GROUP  
**Safety Recall  
Campaign**

MODEL  
**2019MY  
Stinger (CK)  
w/ 3.3L T-GDI**

NUMBER  
**SC196**

**SUBJECT: NEW FUSE KIT INSTALLATION IN JUNCTION BOX (SC196)**

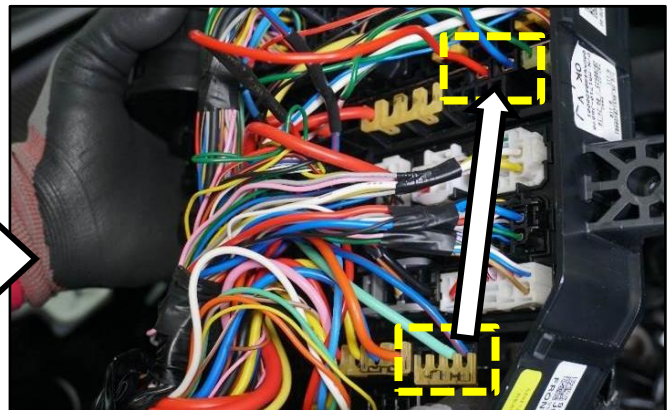
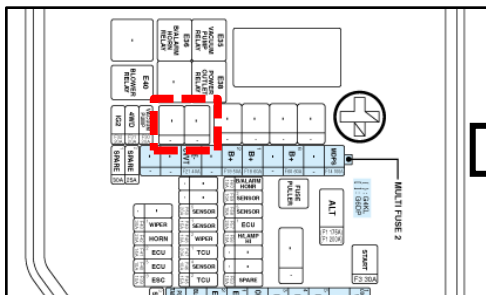
- Insert/lock the two (2) ESC wires onto the junction box **in the new location shown.**

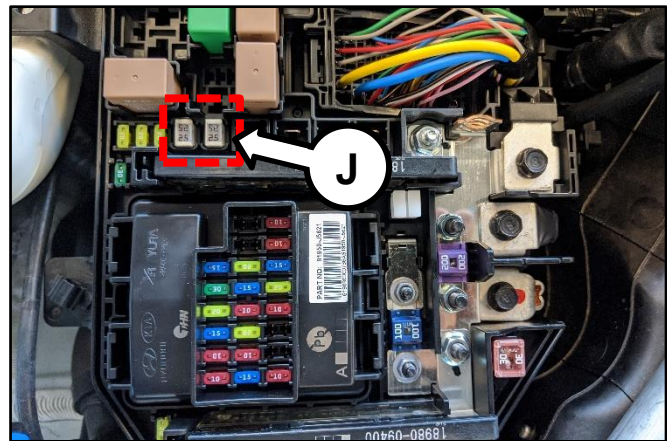
18. Install the two (2) new supplied 25 Amp fuses (J) from the wire kit in the location shown.
